FIRST FLOOR

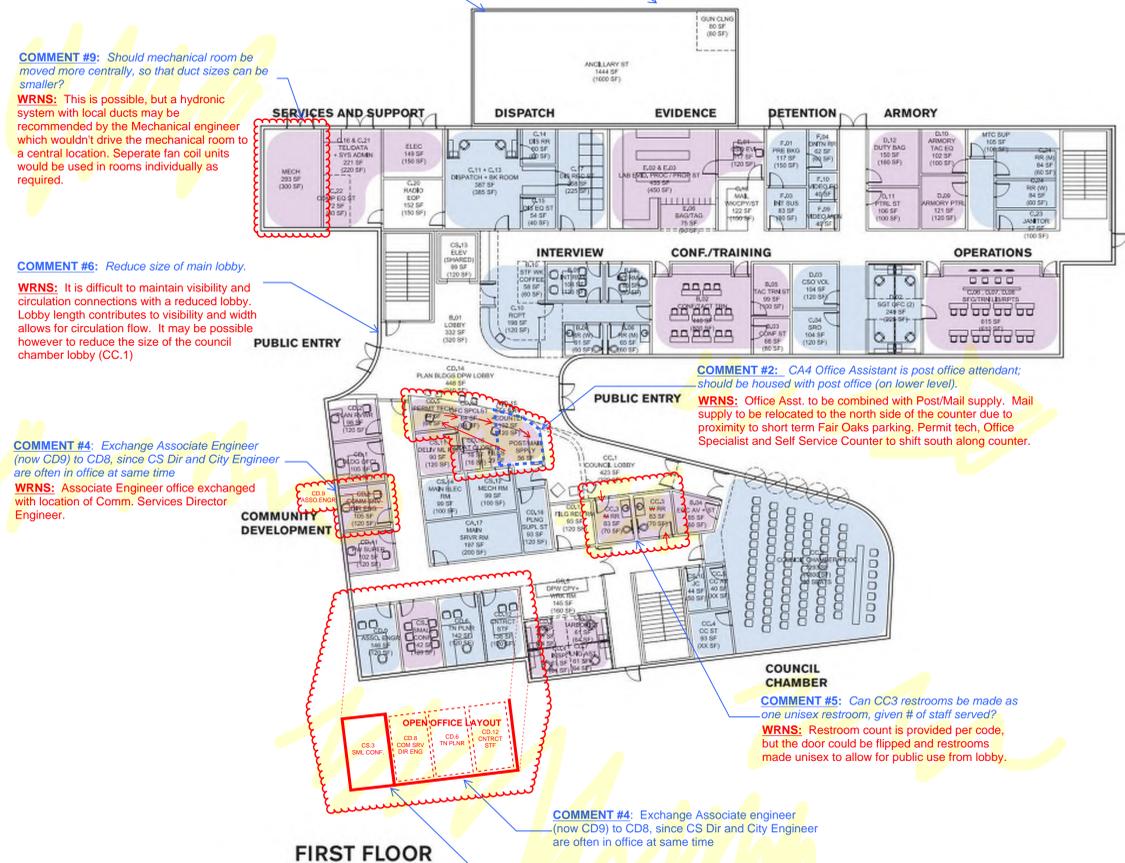
**COMMENT #6:** Reduce size of main lobby.

**COMMENT #4:** Exchange Associate Engineer (now CD9) to CD8, since CS Dir and City Engineer are often in office at same time

**COMMENT #2:** CA4 Office Assistant is post office attendant; should be housed with post office (on lower level).

**COMMENT #5:** Can CC3 restrooms be made as one unisex restroom, given # of staff served?

**COMMENT #4:** Exchange Associate engineer (now CD9) to CD8, since CS Dir and City Engineer are often in office at same time

**COMMENT #3:** Move CS3 to corner location (CD9); revise new CD9, CD6 and CD 12 offices to be partitioned rather than hard walled

**WRNS:** It is difficult to maintain visibility and circulation connections with a reduced lobby. Lobby length contributes to visibility and width allows for circulation flow. It may be possible however to reduce the size of the council chamber lobby (CC.1)

**WRNS:** Associate Engineer office exchanged with location of Comm. Services Director Engineer.

**WRNS:** Office Asst. to be combined with Post/Mail supply. Mail supply to be relocated to the north side of the counter due to proximity to short term Fair Oaks parking. Permit tech, Office Specialist and Self Service Counter to shift south along counter.

**WRNS:** Restroom count is provided per code, but the door could be flipped and restrooms made unisex to allow for public use from lobby.

**WRNS:** See clouded alternate layout sketch.

SECOND FLOOR

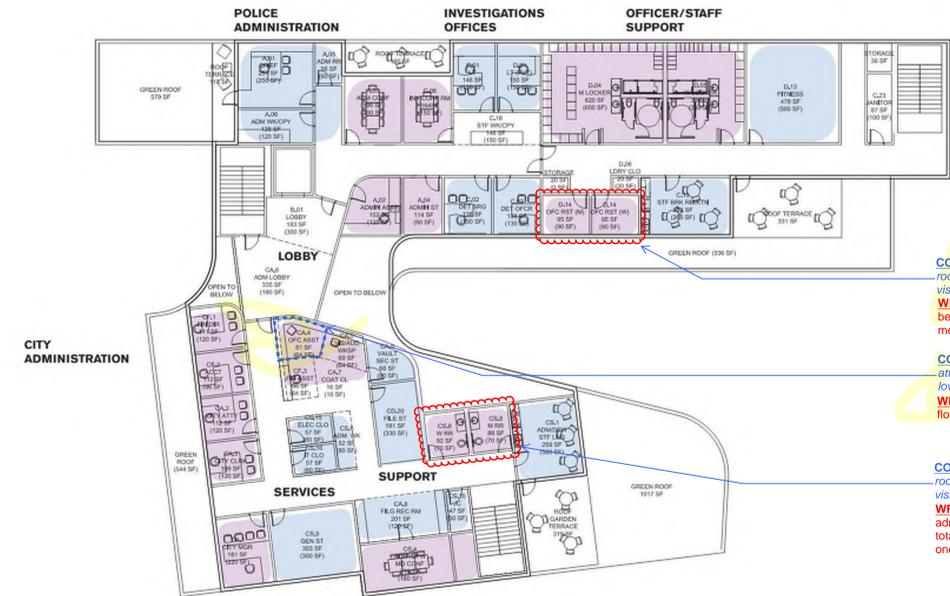
**COMMENT #8:** Combine D14's into 1 unisex room, if adequate to serve number of staff and visitors given proximity to locker room restrooms.

**COMMENT #2:** CA4 Office Assistant is post office attendant; should be housed with post office (on lower level).

**COMMENT #7:** Combine CS8's into 1 unisex room, if adequate to serve number of staff and visitors (max 5)

**WRNS:** Resting rooms are provided for officer sleeping areas between tightly scheduled shifts or court appearances. Separate men's and women's resting rooms are recommended. (2 total)

**WRNS:** See plan revision associated with comment #2 on first floor.

**WRNS:** Restroom count is provided per code for admin building total requirement. Therefore, the total WC count cannot be reduced, but if desired one WC could be relocated to the first floor.
